SAN FRANCISCO PLANNING DEPARTMENT

Memo to the Planning Commission

HEARING DATE: JUNE 14, 2018

Date: June 7, 2018
Case No.: **2017-001283CUA**
Project Address: **792 Capp Street**
Zoning: RTO-M (Residential Transit Oriented-Mission) Zoning District
Calle 24 Special Use District
40-X Height and Bulk District
Block/Lot: 3637/019B
Project Sponsor: Lucas Eastwood
3520 20th Street
San Francisco, CA 94110
Staff Contact: Michael Christensen – (415) 575-8742
michael.christensen@sfgov.org
Recommendation: **Approval with Conditions**

1 EXISTING SITE PLAN
3/16" = 1'-0"

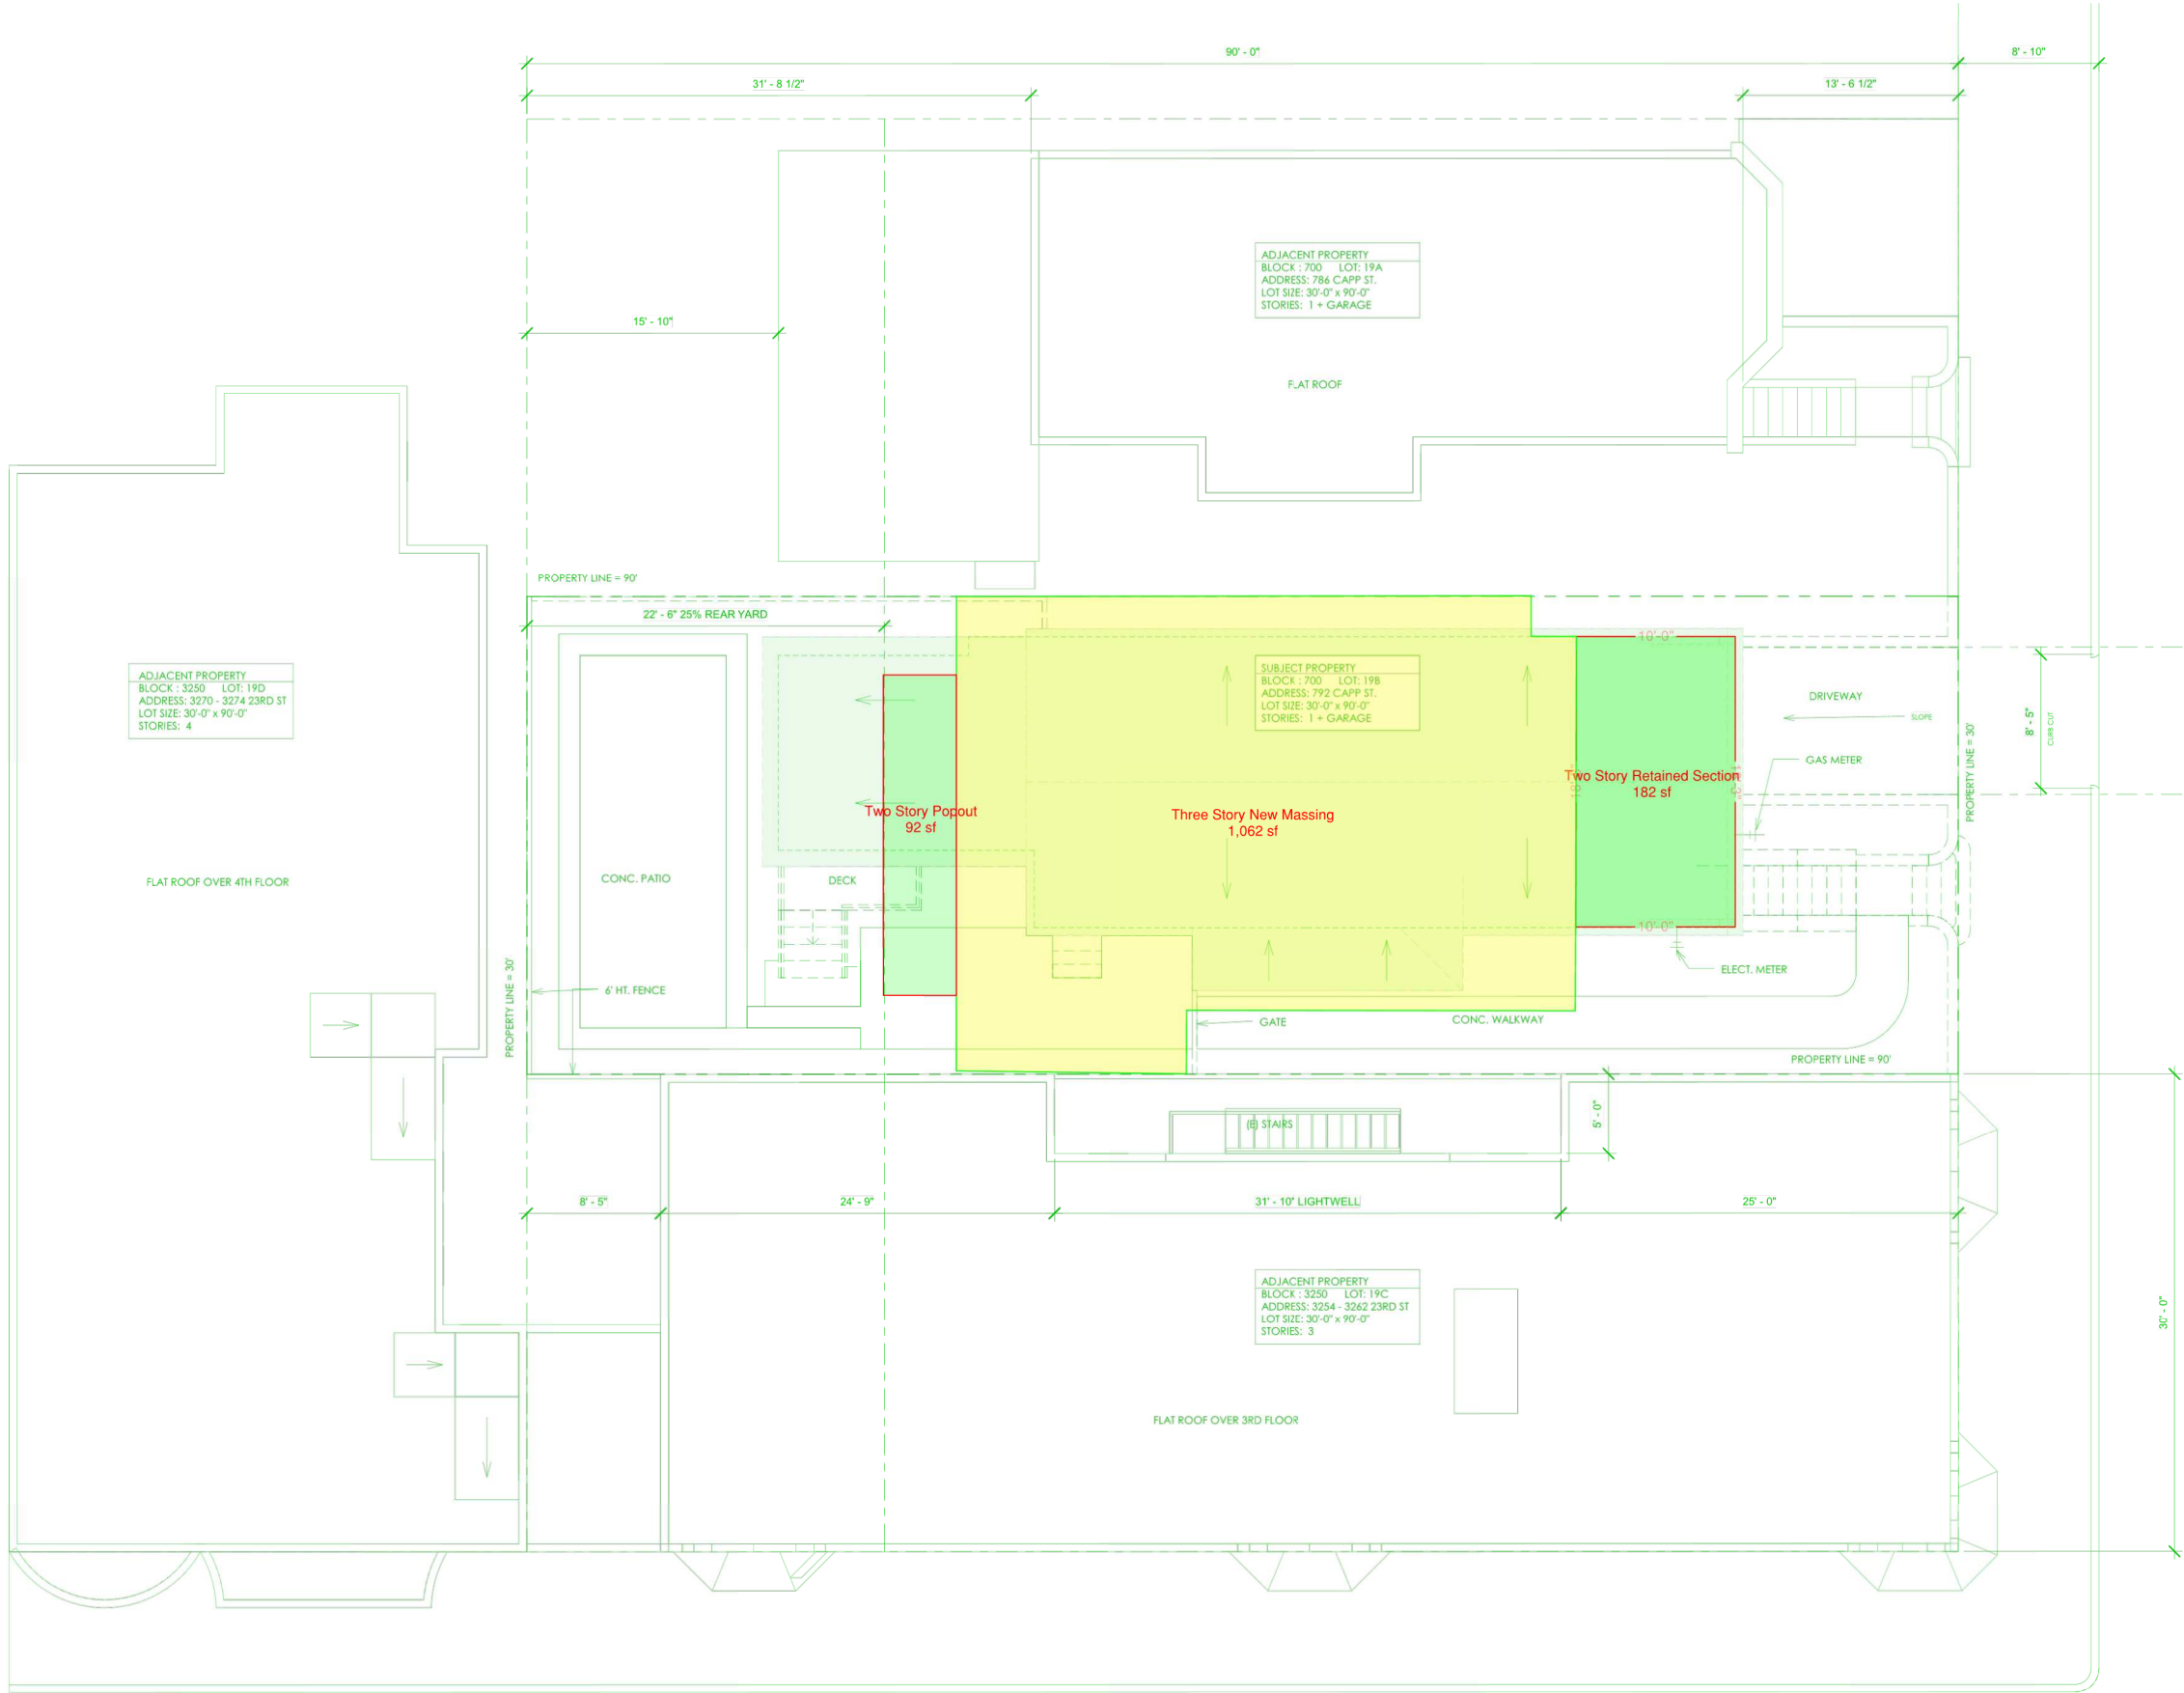
1. A block map detailing what other properties in the block are not designated as historic resources and are unlikely to contain rent controlled units, making them likely to meet the required findings for demolition of Planning Code Section 317.
2. An overlay of the existing site plan detailing staff's recommended modification to the project to retain the first ten feet of the existing building.

1 PROPOSED SITE PLAN
3/16" = 1'-0"

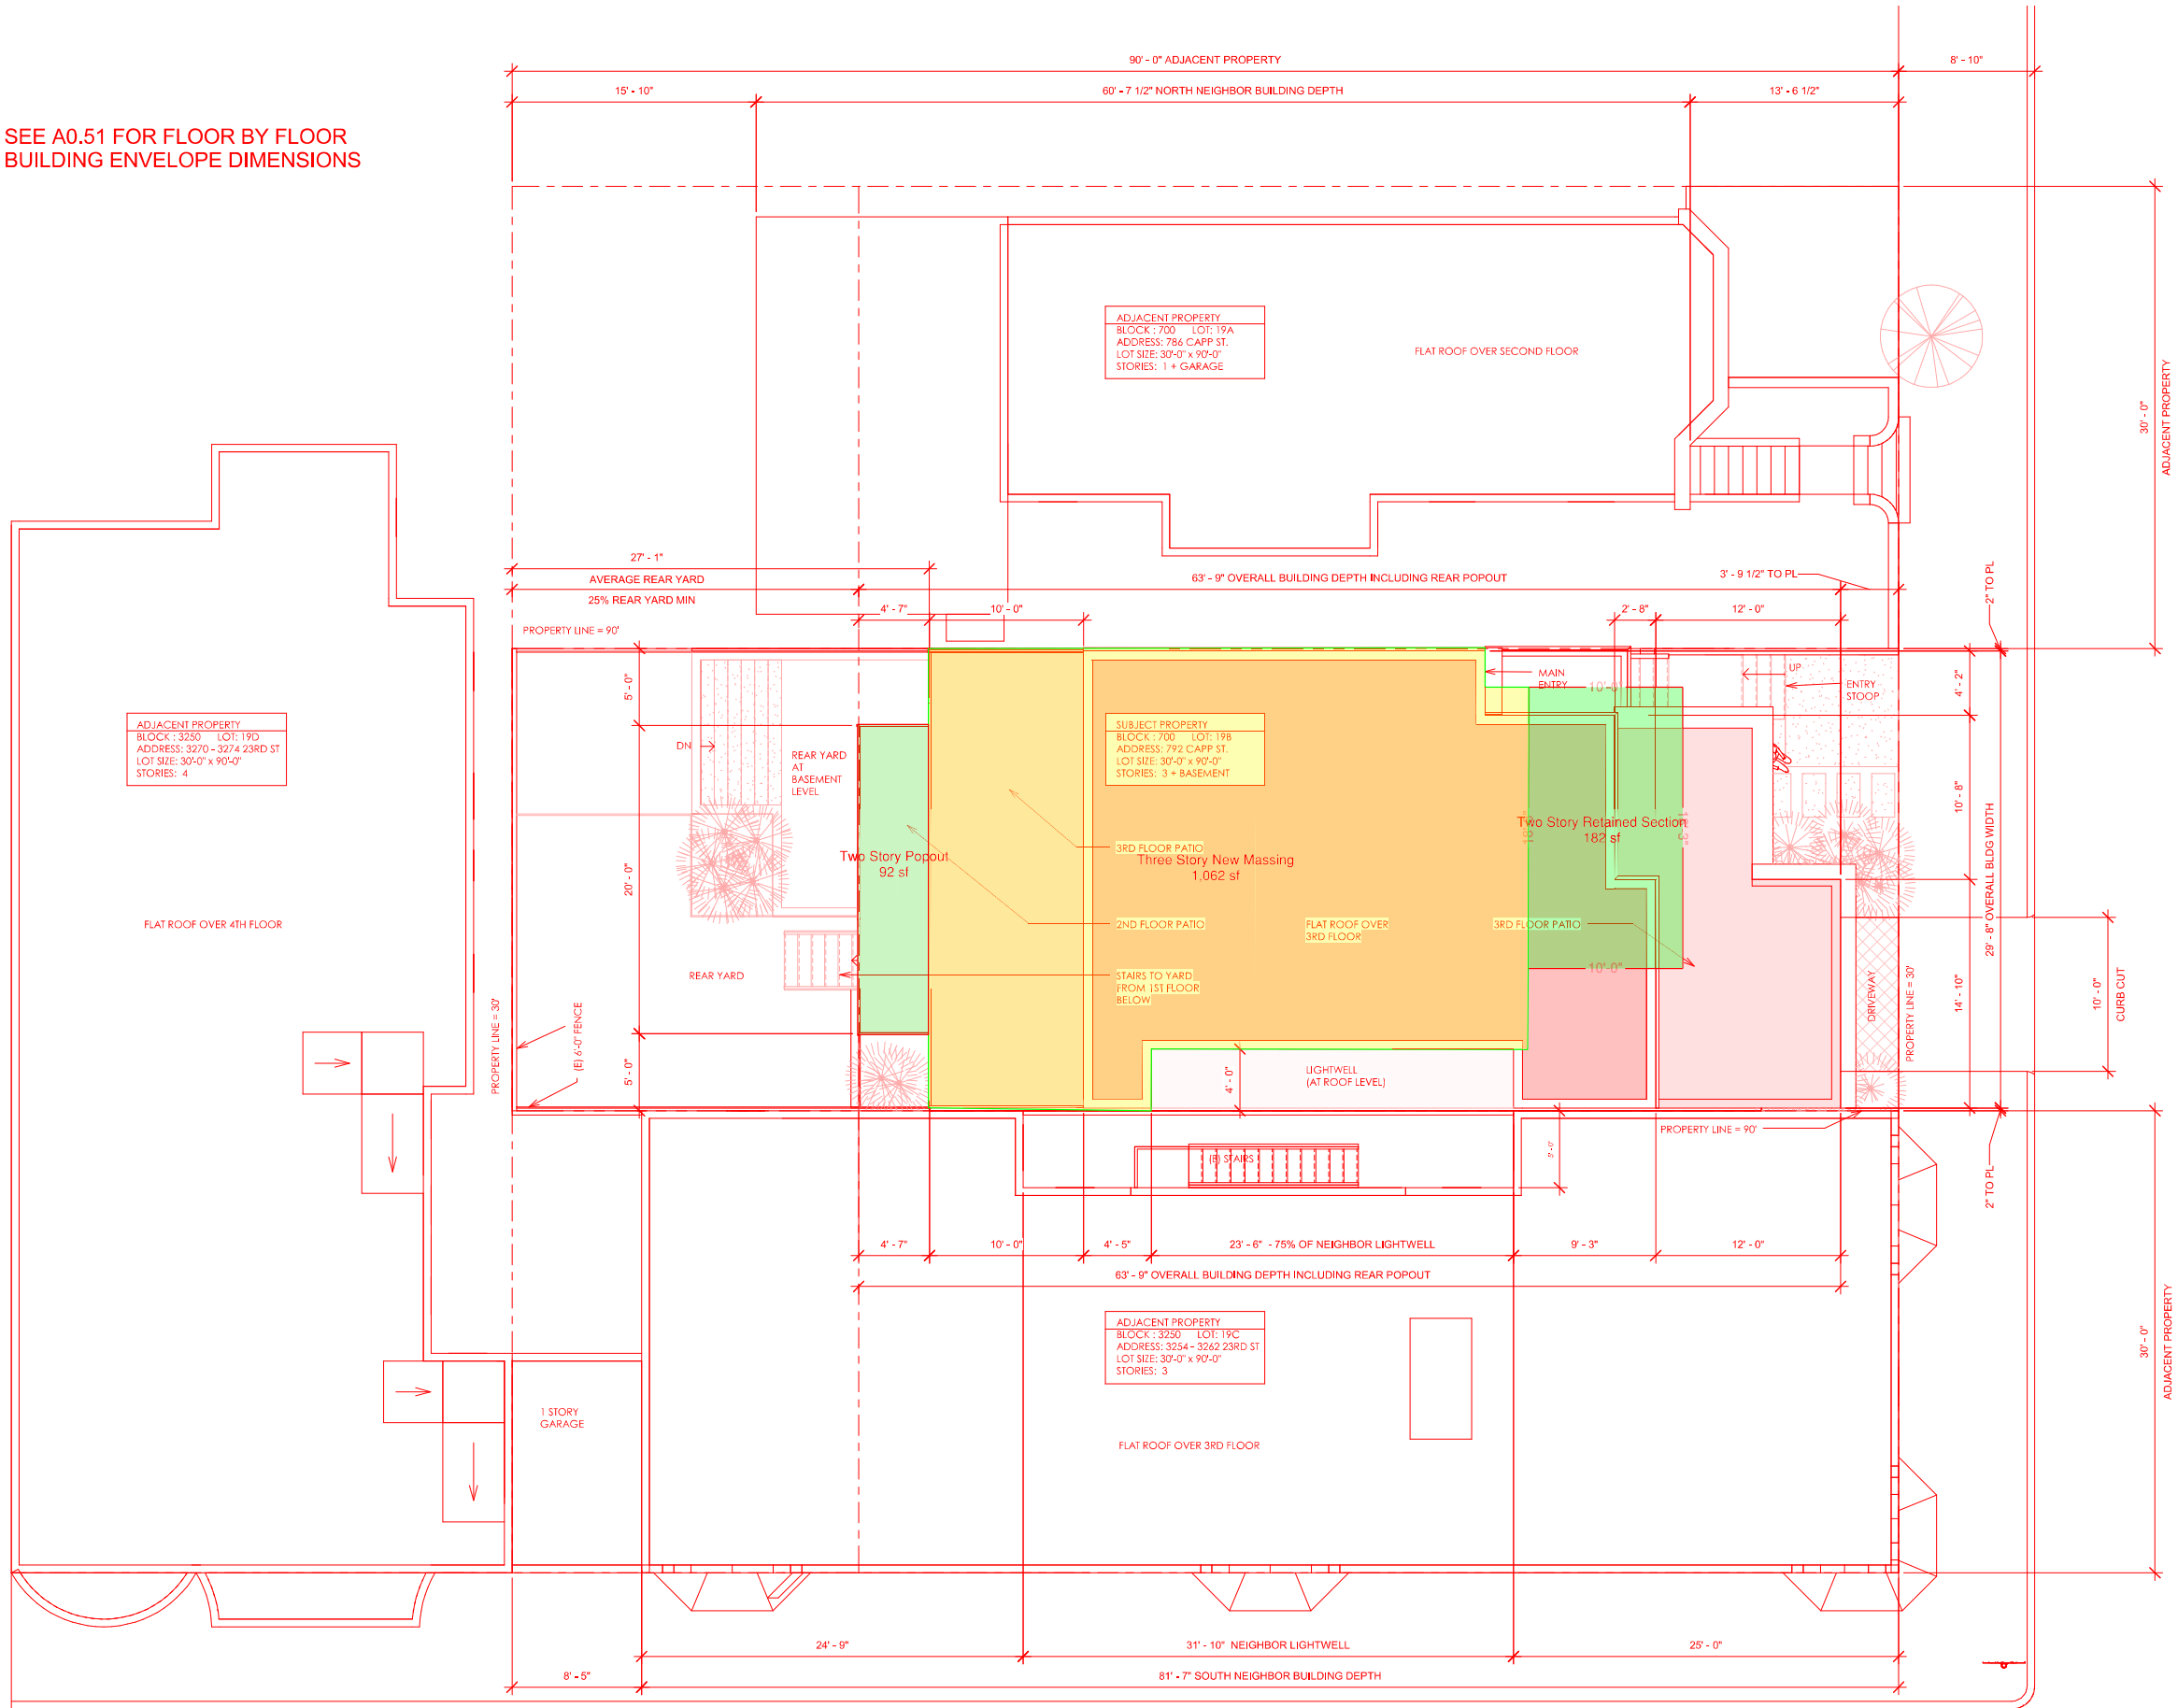
3. An overlay of the proposed site plan detailing staff's recommended modification to the project to retain the first ten feet of the existing building.

WINDER GIBSON ARCHITECTS
MARKUP OF PLANNING DEPT OVERLAY OF ADDITION/
RENOVATION PROPOSAL FOR 792 CAPP STREET

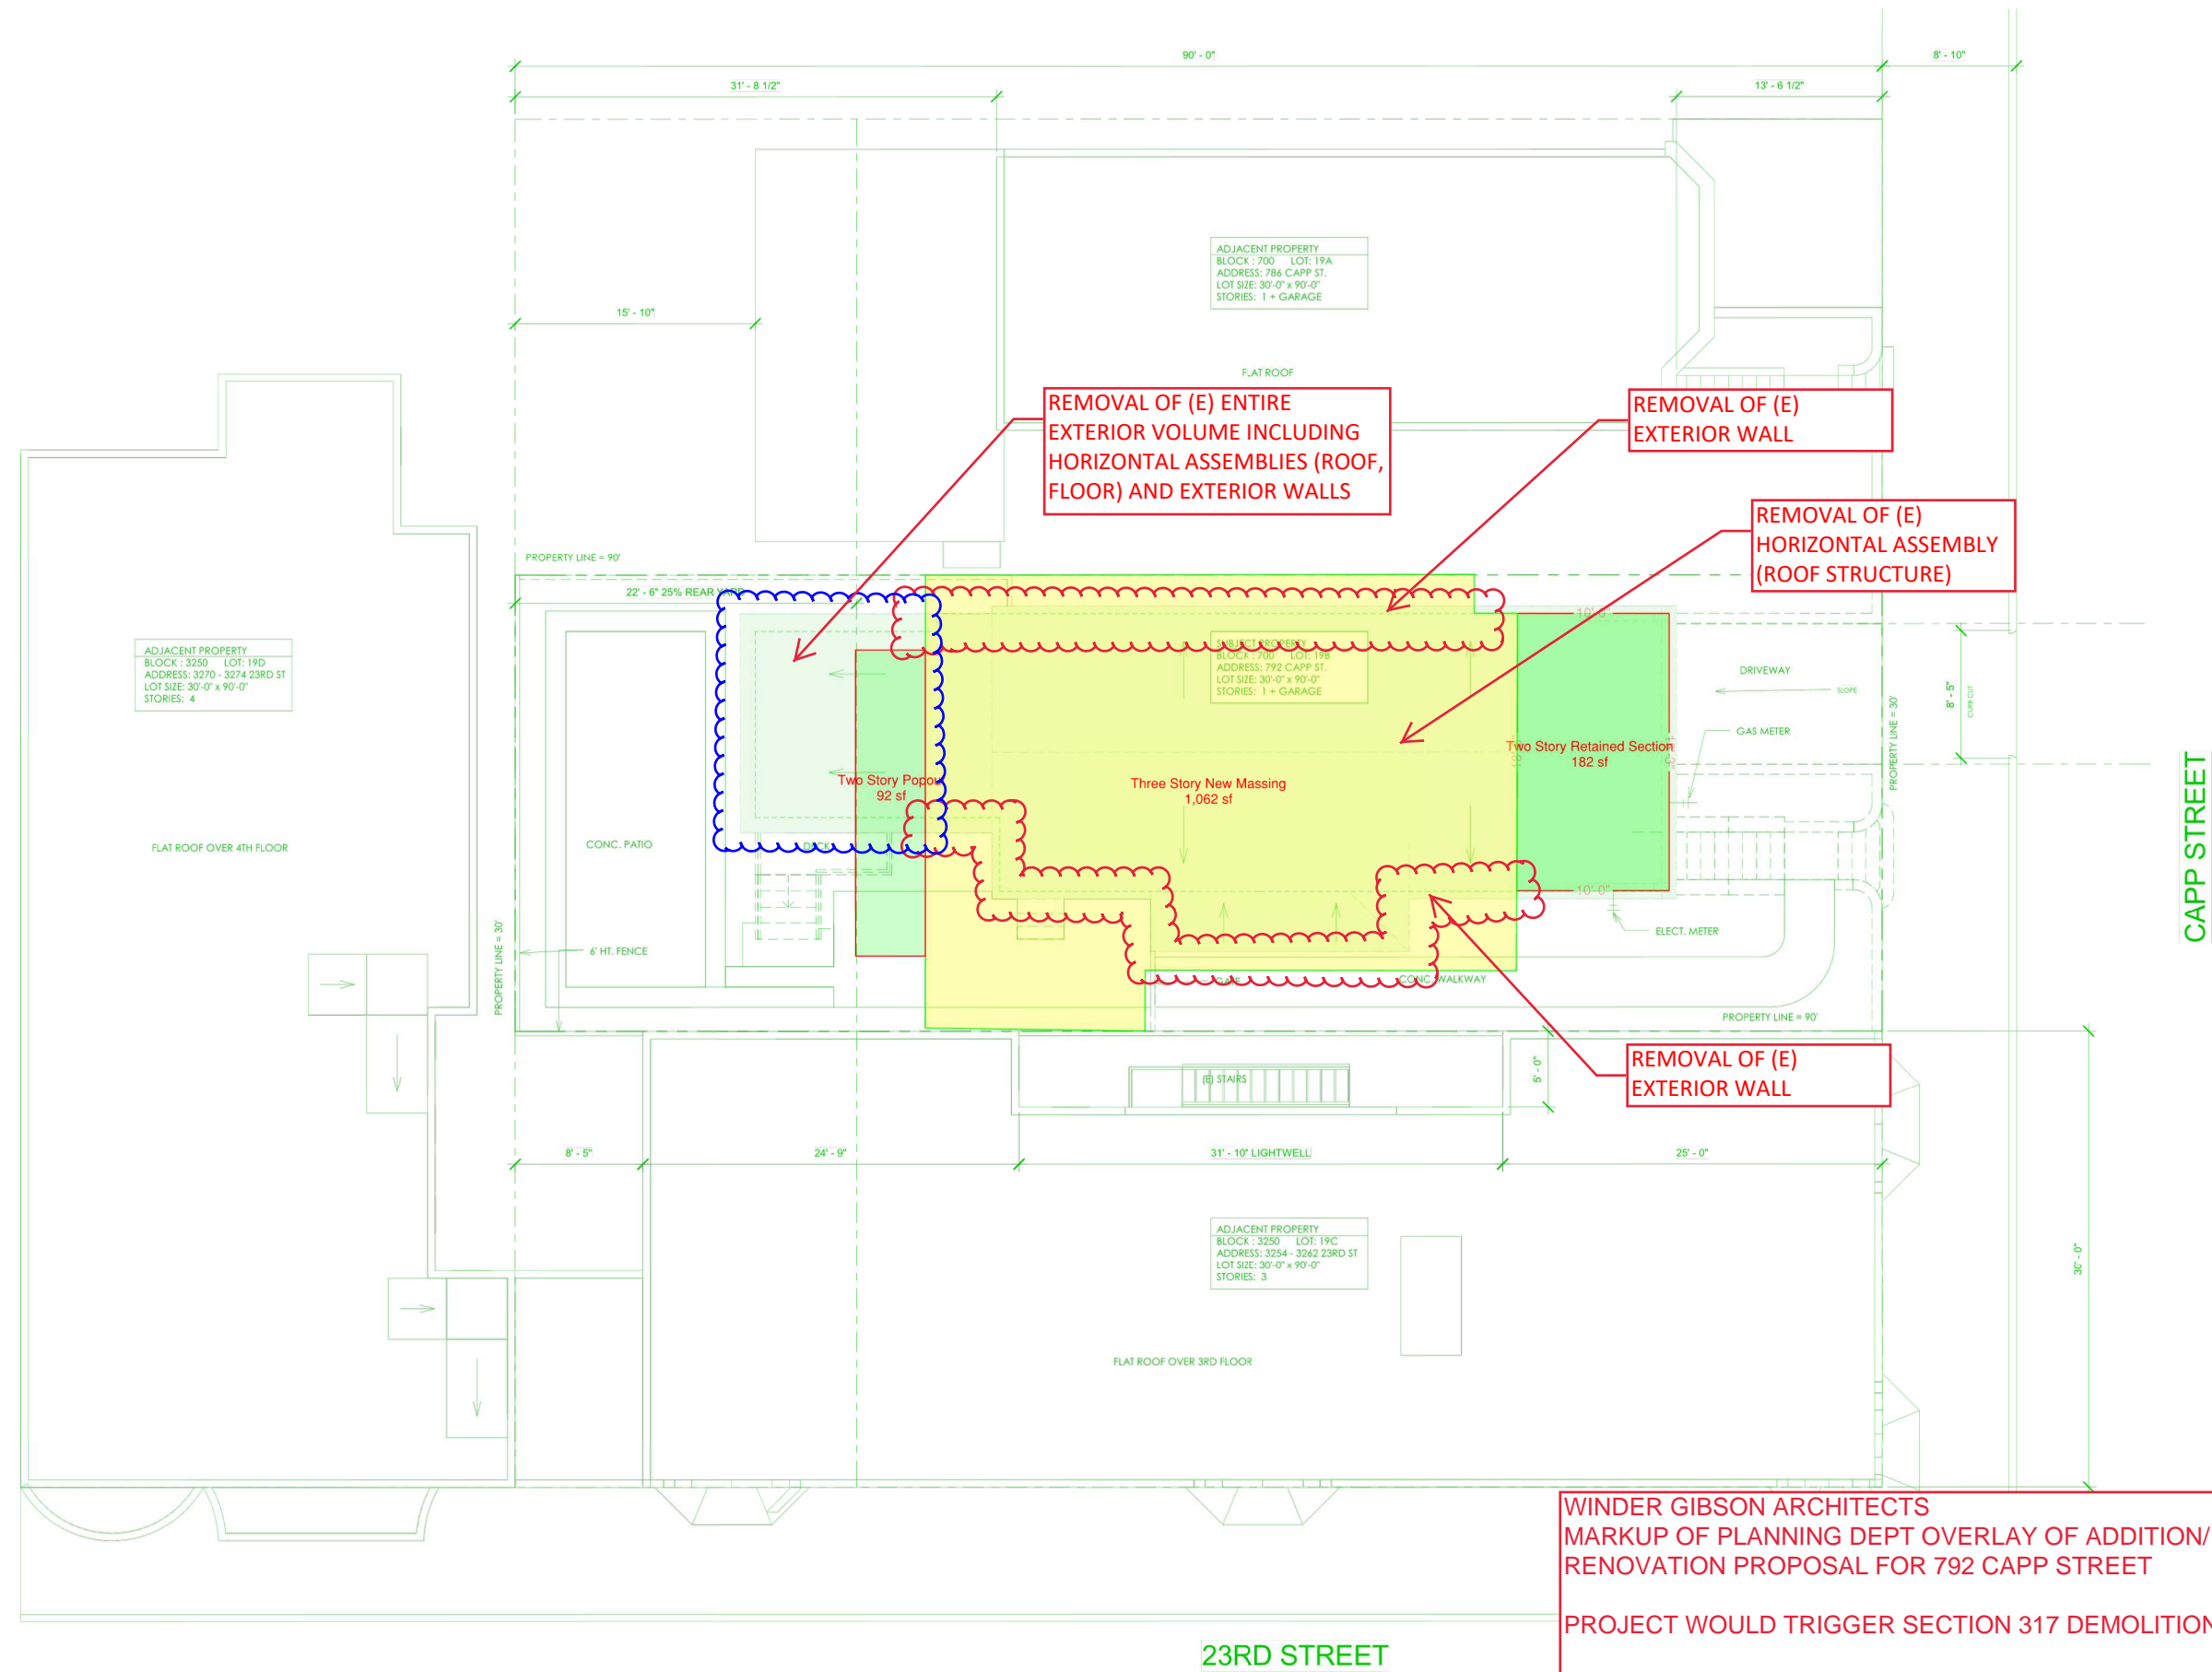
Please see the attached markup showing the Planning proposal overlaid over the existing conditions. It clearly demonstrates that the project would remove a substantial percentage of the total exterior walls and horizontal assemblies. This would invoke Section 317 'tantamount to demolition' and would require a conditional use authorization, thus not saving the time that Planning Staff believes will be saved.
